**TYRONE TOWNSHIP  
REGULAR BOARD MEETING AGENDA  
DECEMBER 21, 2021 – 7:00 P.M.  
(810) 629-8631  
clerk@tyronetownship.us**

1. Lake Urban Crossings PUD Preliminary Site Plan.

**Subject: Agenda Request, Lake Urban Crossings Preliminary PUD Plan  
Recommendation for Approval**

## **Preliminary Site Plan/Planned Unit Development Review for Tyrone Township, Michigan**

# PRELIMINARY LIMITS OF CONSTRUCTION PLAN LAKE URBAN CROSSINGS P.U.D.

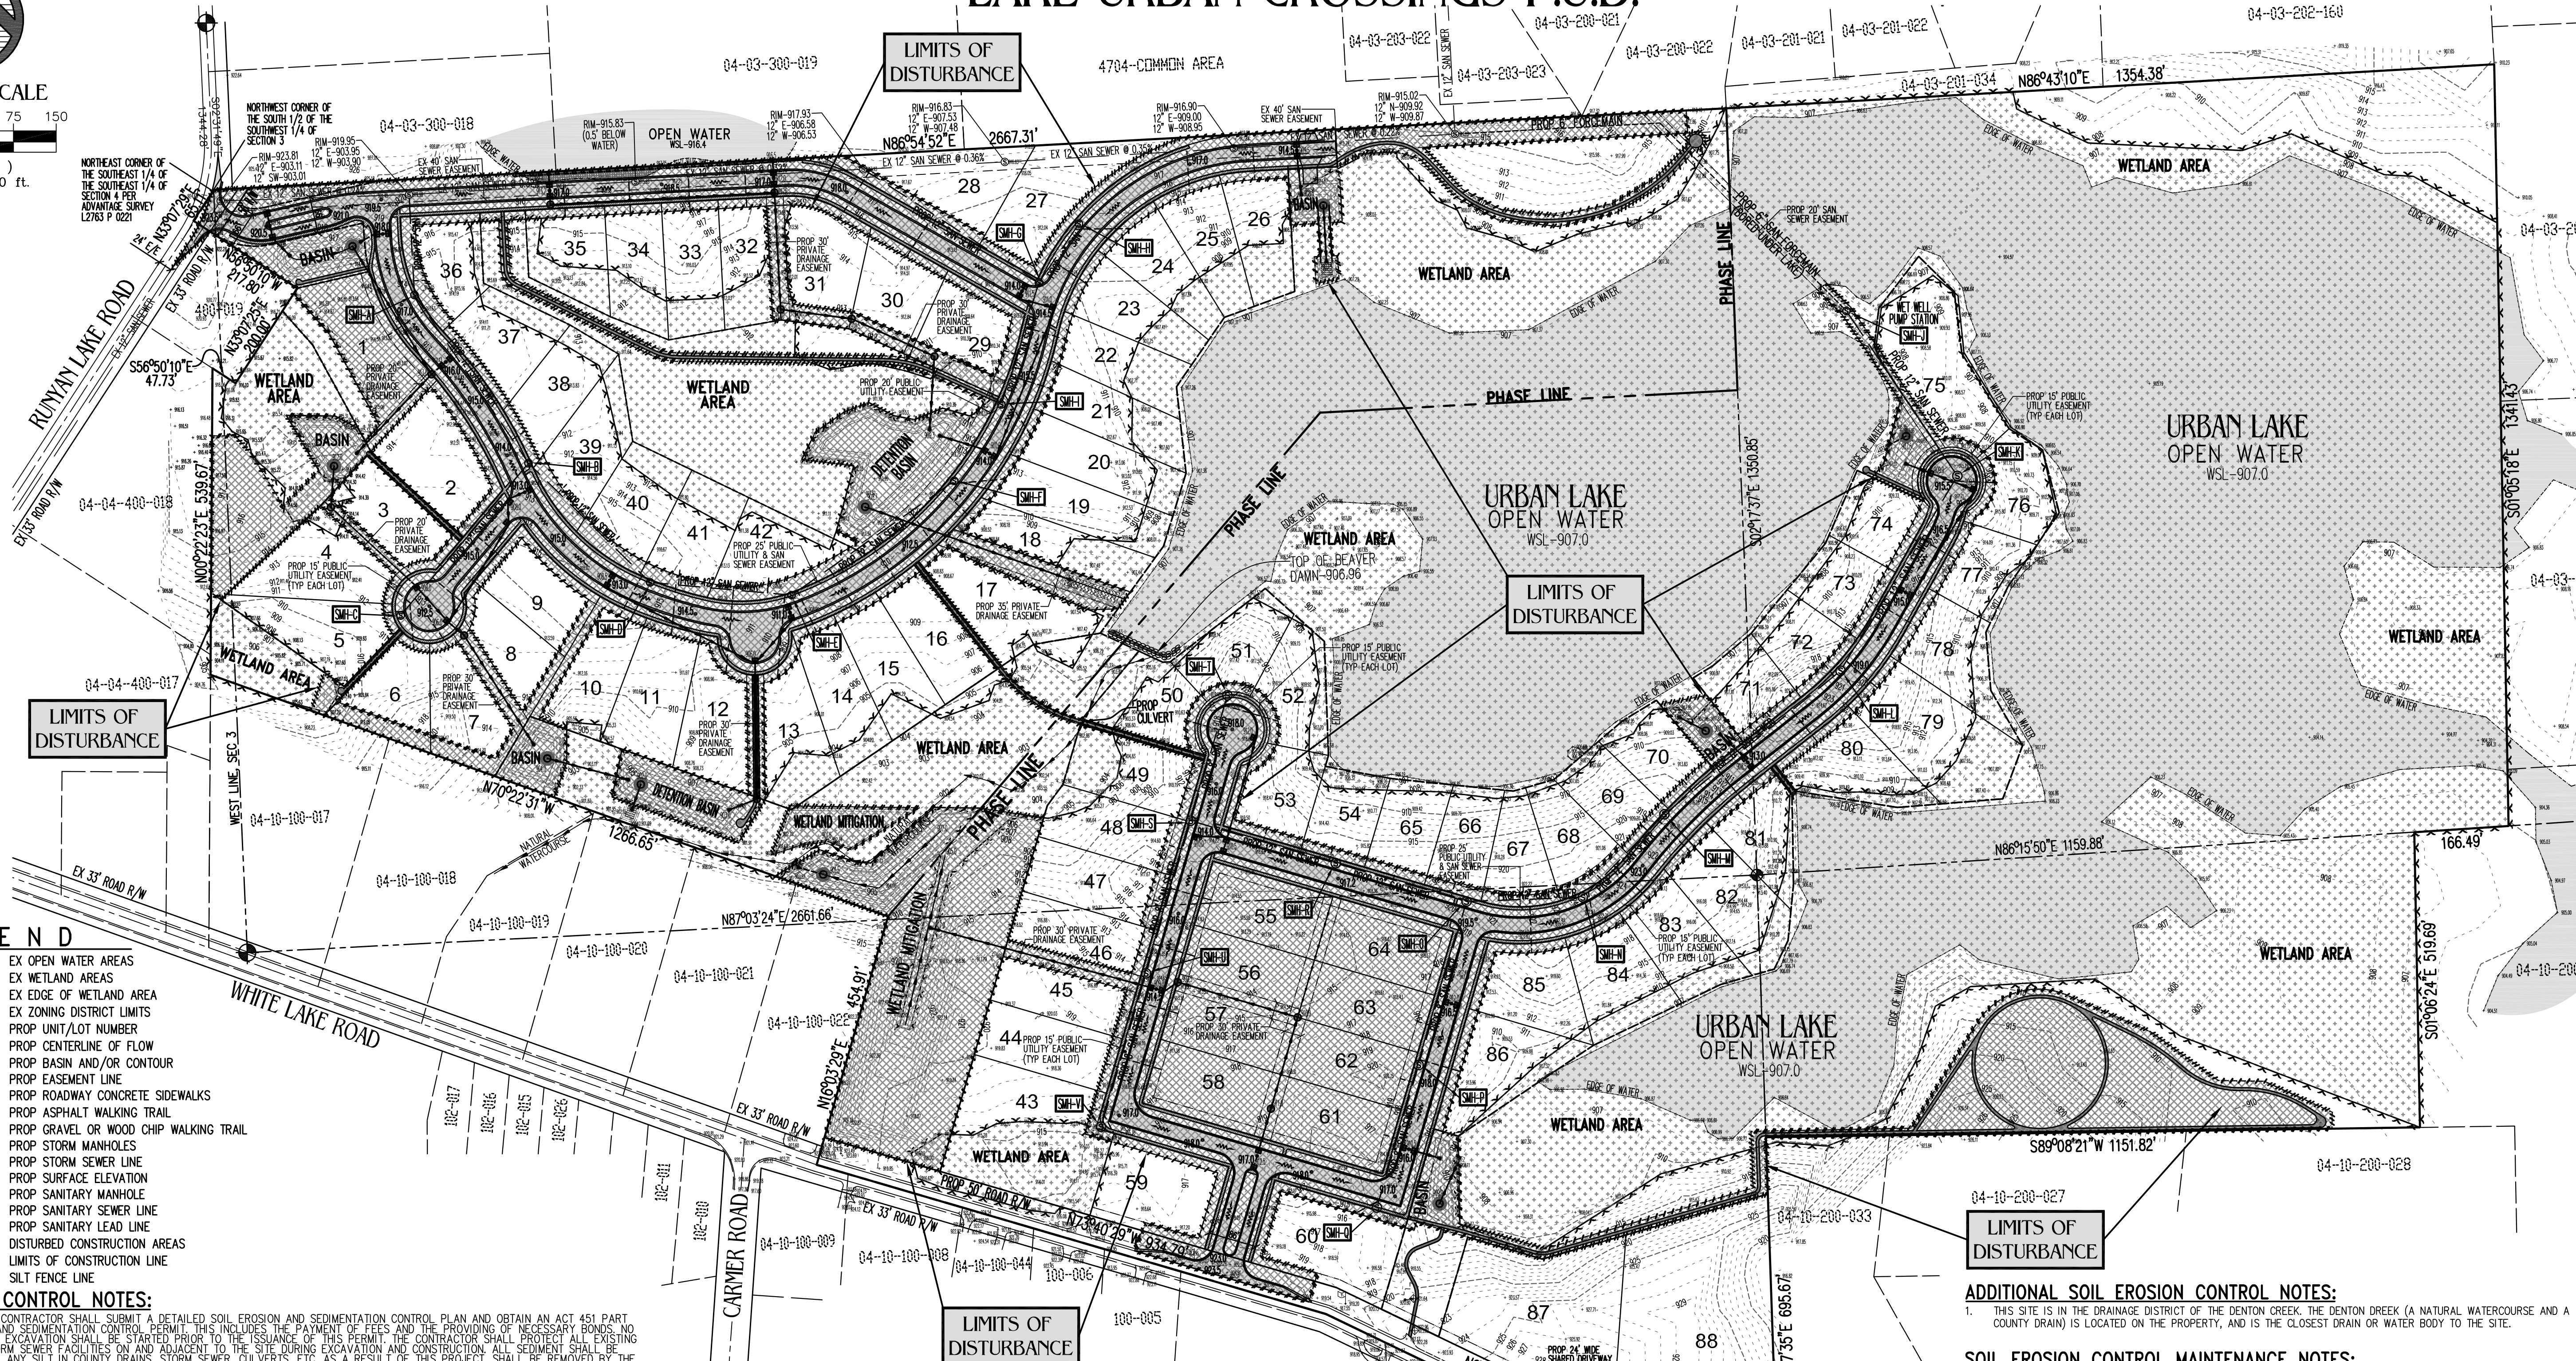
**Comments:** *The preliminary plan for the proposed planned unit development shows the limits of disturbed areas on Sheet P-7. This area will include some grading and filling adjacent to neighboring properties, but it is not clear that the proposed work would create a negative impact.*

**Comments:** *The proposed planned unit development includes areas that would be preserved in their natural state or with little disturbance. Sheet P-7 shows the limits of disturbed areas.*

# PRELIMINARY FIRE TRUCK ROUTE PLAN LAKE URBAN CROSSINGS

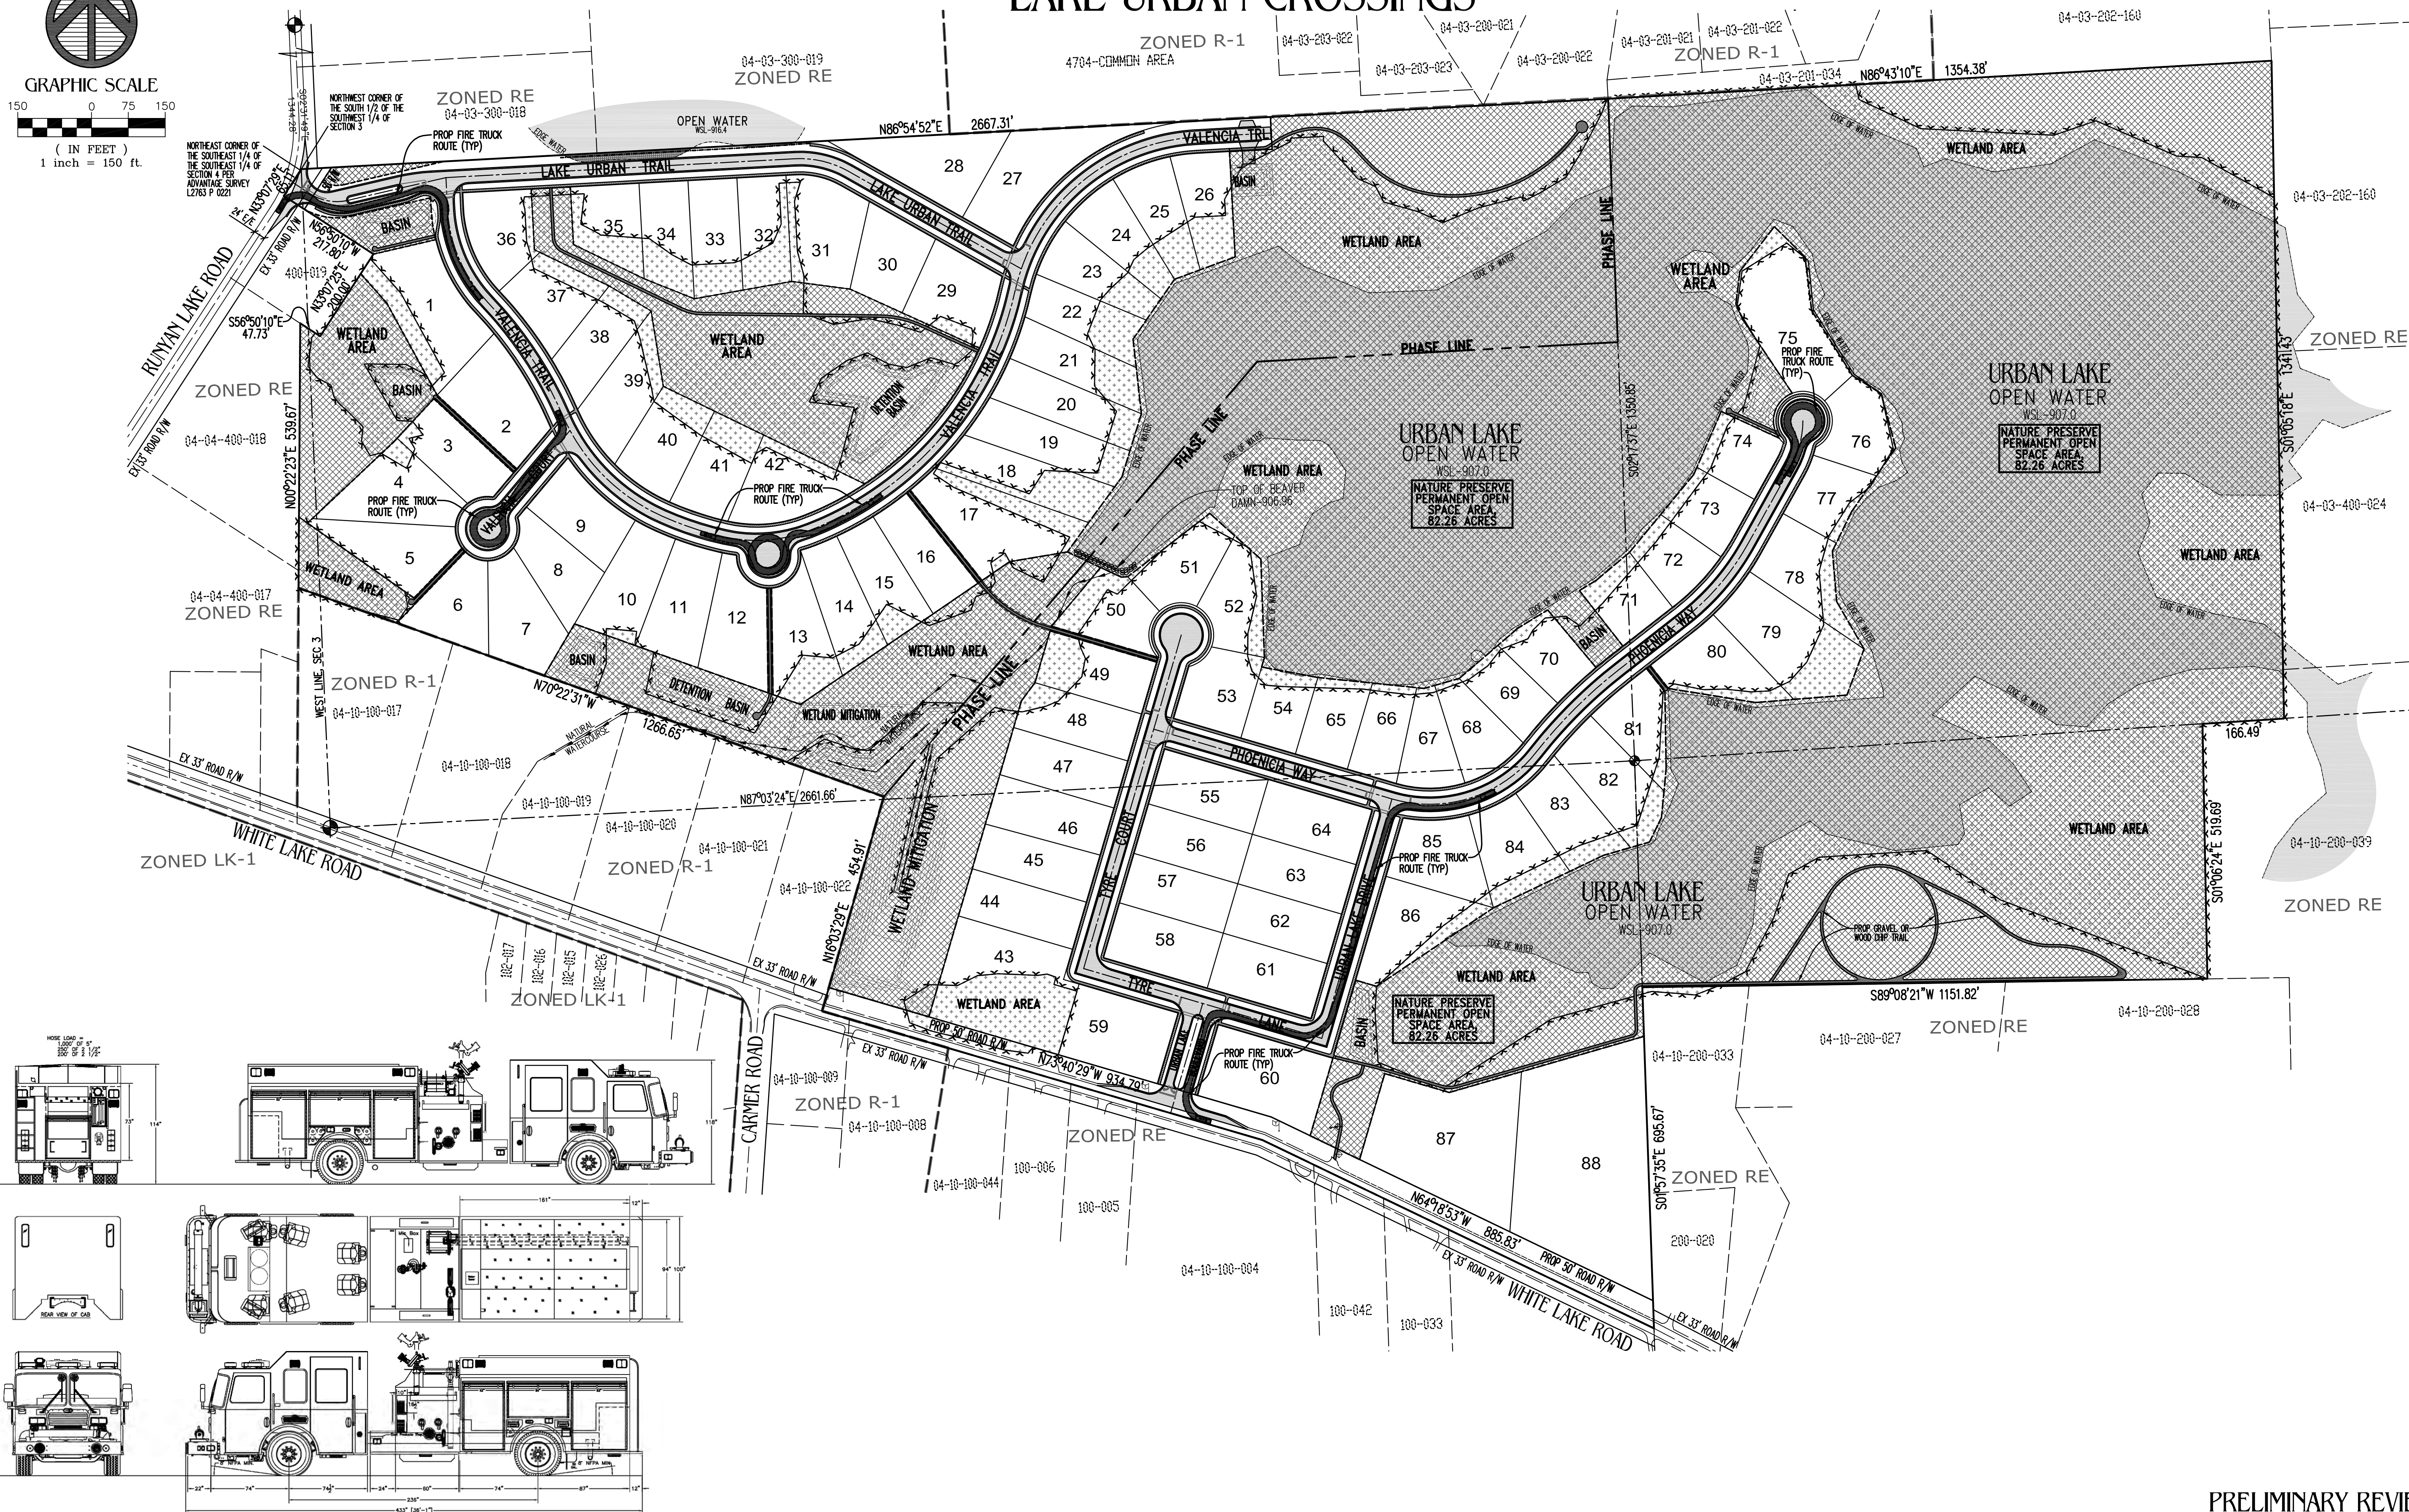
**Comments:** *The proposed road system would allow direct access to all of the proposed lots. Sheet P-8 shows fire apparatus access through most of the site. It is likely that a turnaround will be required at the eastern end of Valencia.*
